ADA Curb Ramp New Construction Inspection Form (Perpendicular)

Nw 289th

24952.54

Nw Kaye

PERPENDICULAR RAMP (PR)

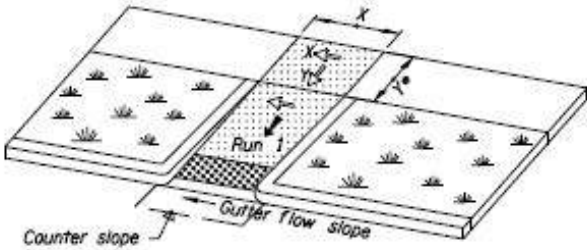
RR1 ICRR, IITD
